early design guidance #2

Property Address:
400 Fairview Ave. N
Seattle, WA
DPD Project#: 3013102

Owner: Skanska USA Commercial Development Inc.
Owner / Applicant: Murphy McCullough

Architect: SkB Architects
2333 3rd Ave. Seattle, WA 98121
Architect Contact: Brian Collins-Friedrichs
206.903.0575
bcollinsfriedrichs@skbarchitects.com

street level revised plan

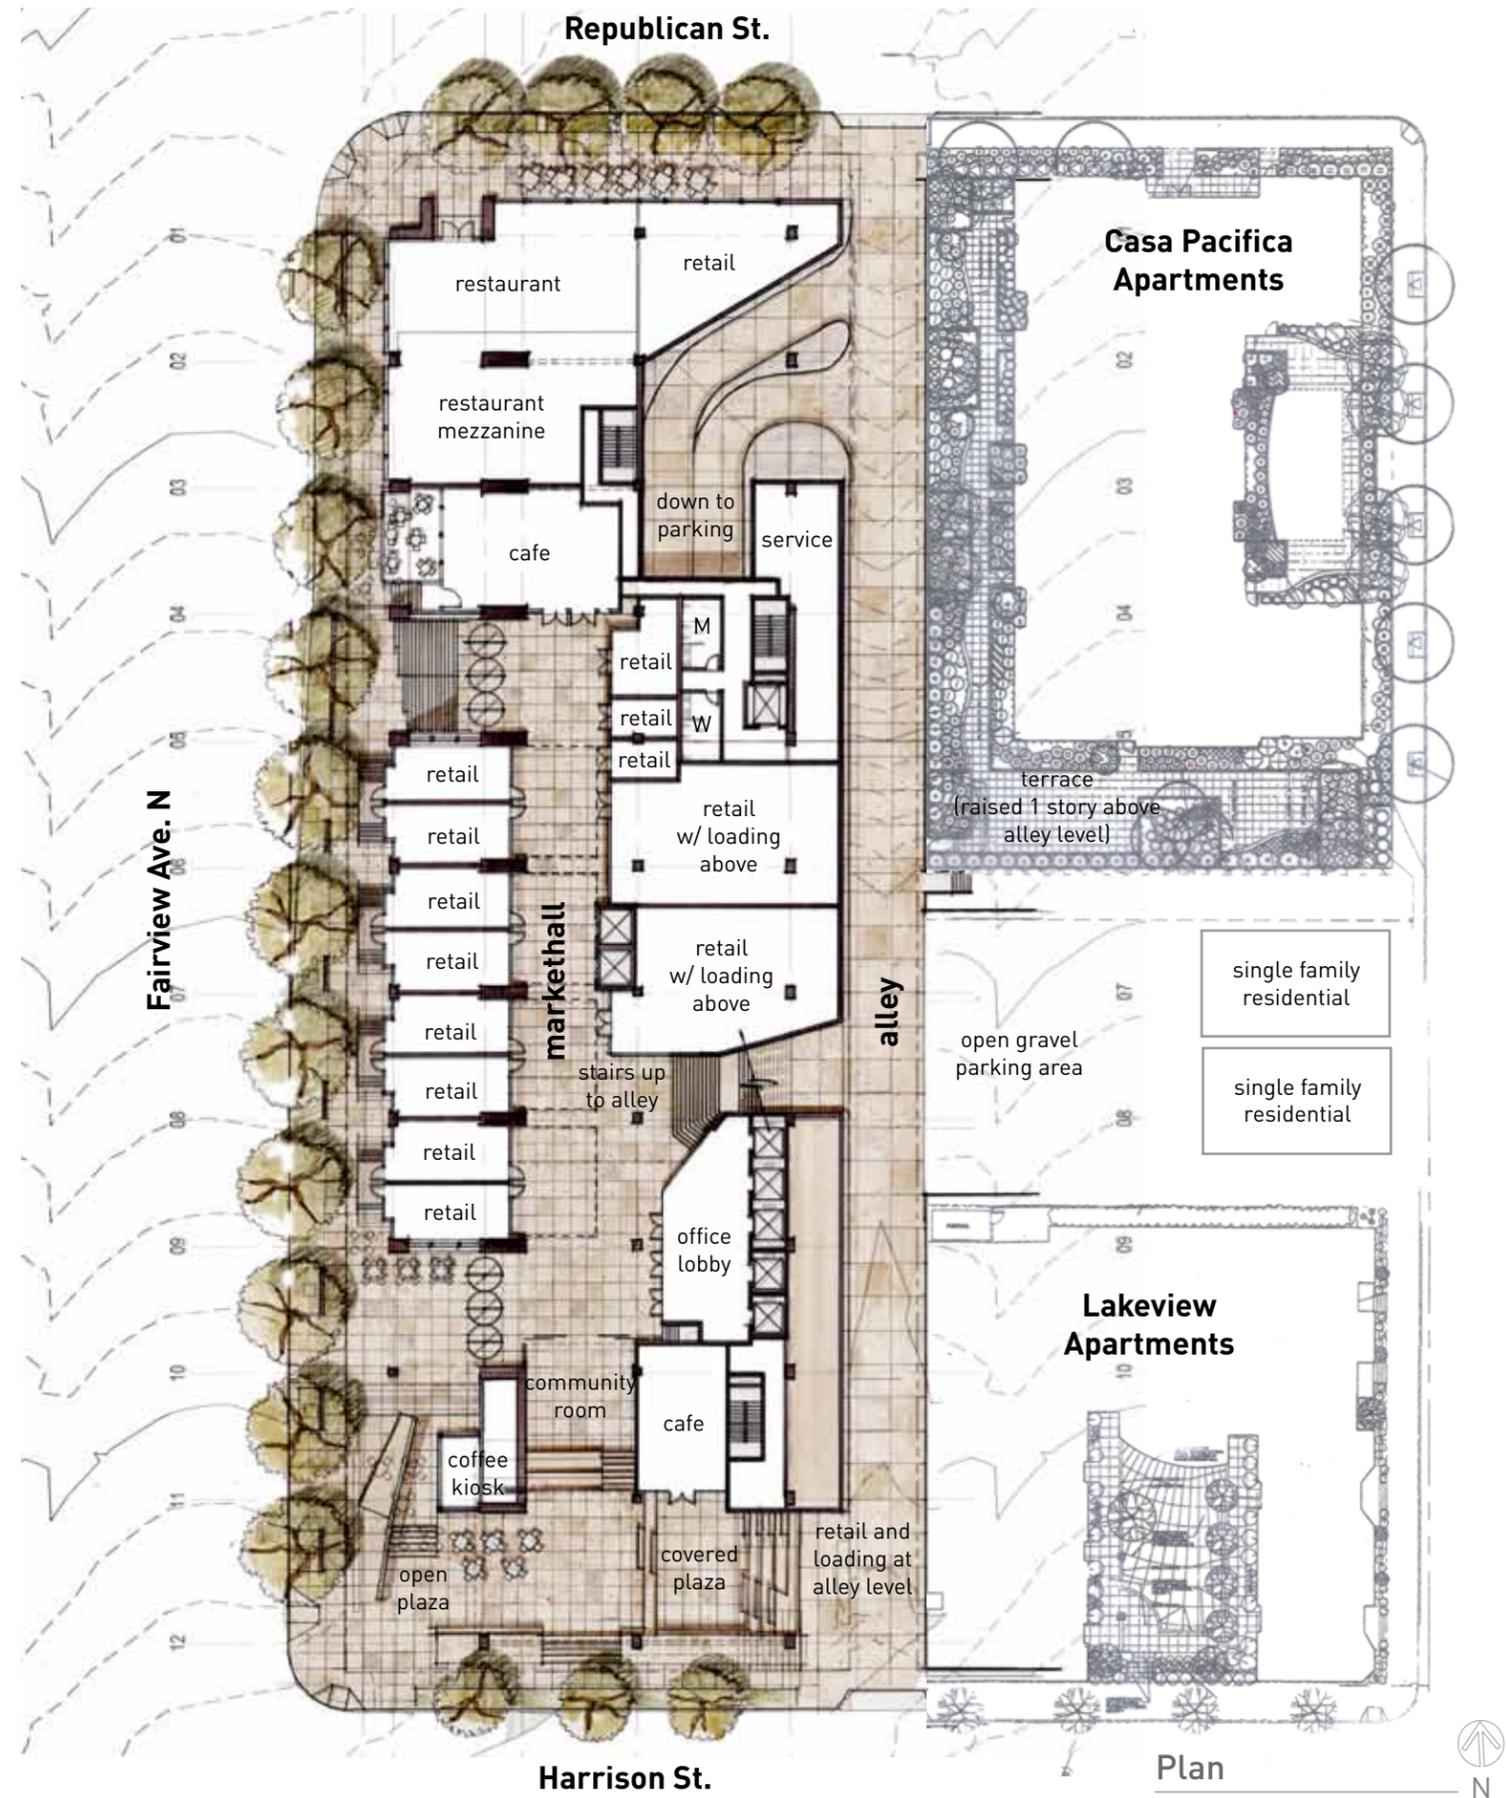
recommendation checklist

✓	a. Demonstrate active street frontage
✓	b. Demonstrate human scale
✓	c. No blank walls at Fairview

Perspective sketch: alley looking from Harrison street

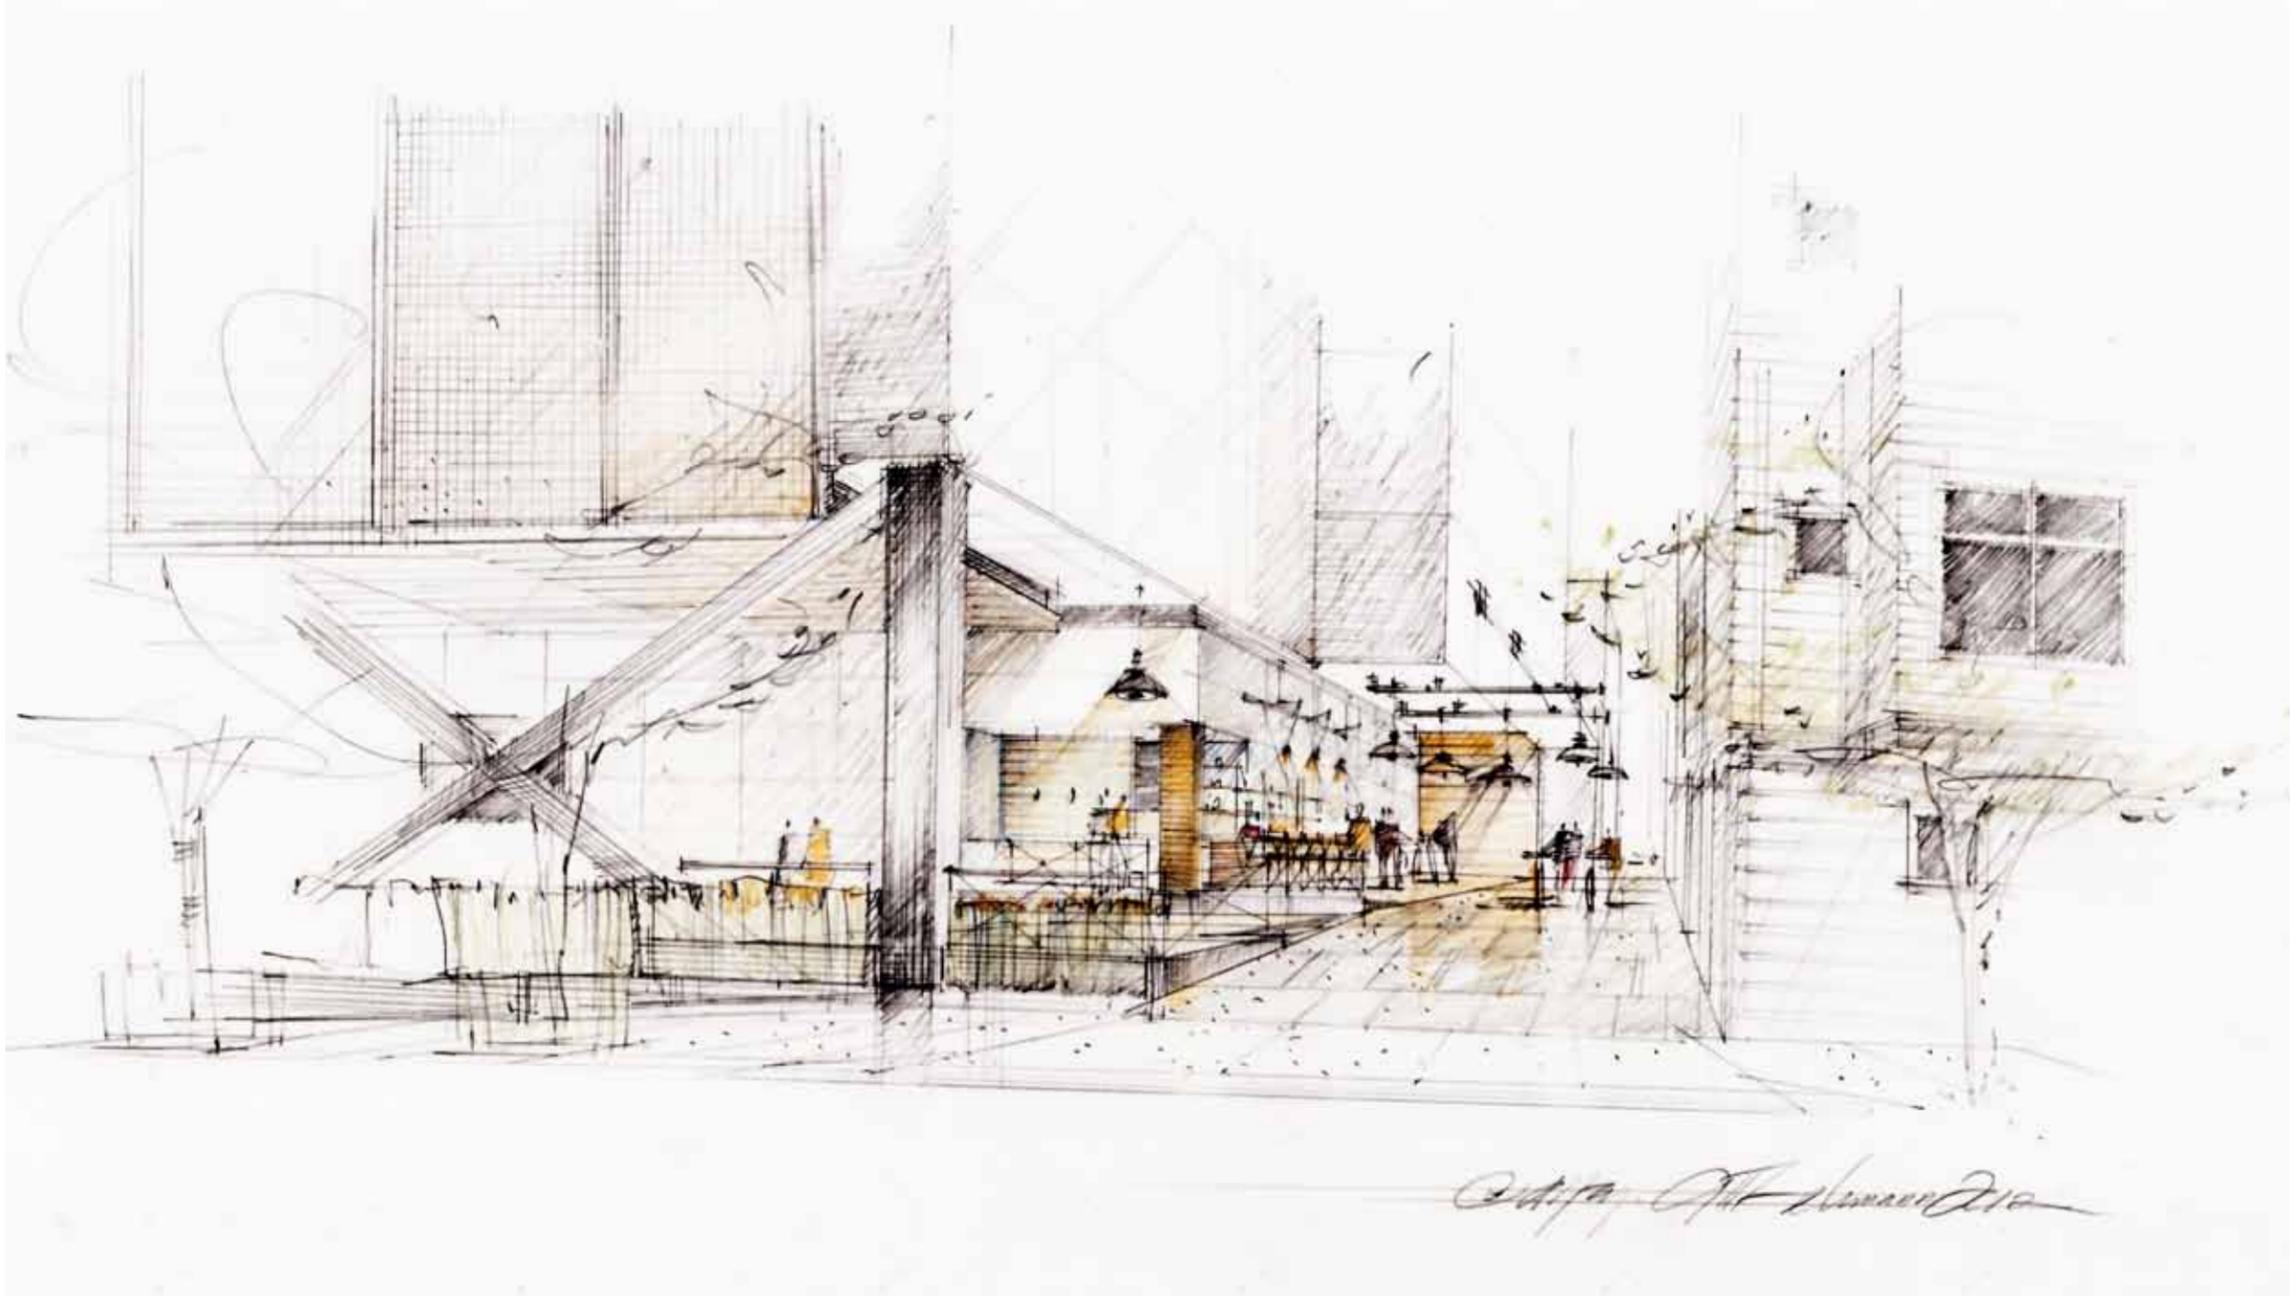
recommendation checklist

✓	a. Explore south-bound alley traffic
✓	b. Develop successful multi-use alley
✓	c. Relate alley use to existing conditions

alley zones of use

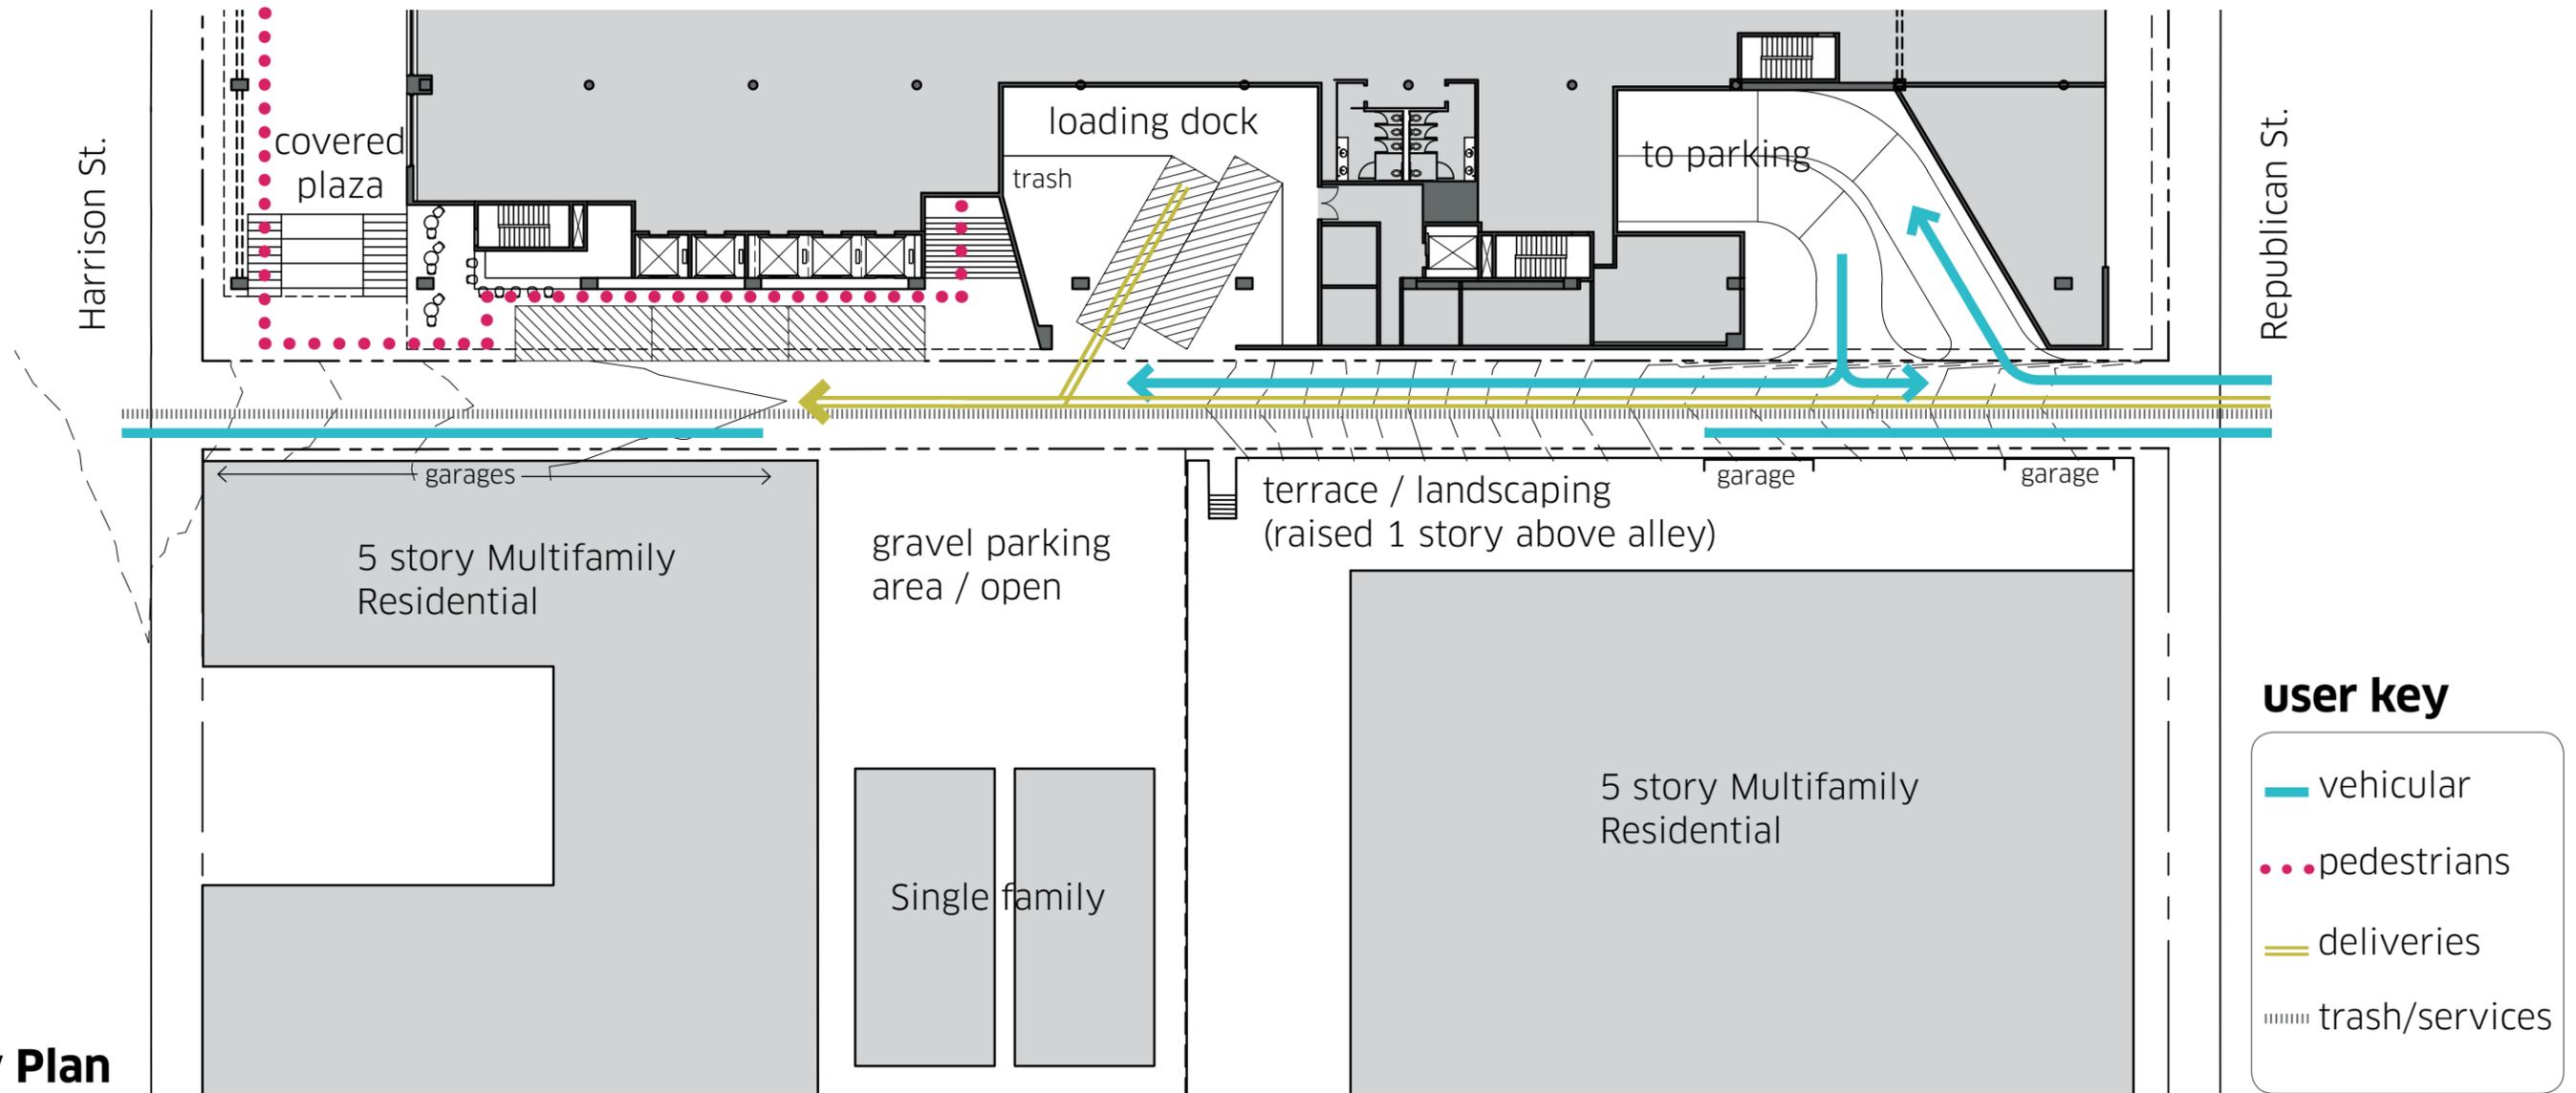
pedestrian zone located at south end for ease of pedestrian access to the plaza

loading zone functionally located in the middle at the flattest part of the alley

parking zone located at the steepest and lowest part of the alley; per traffic consultant
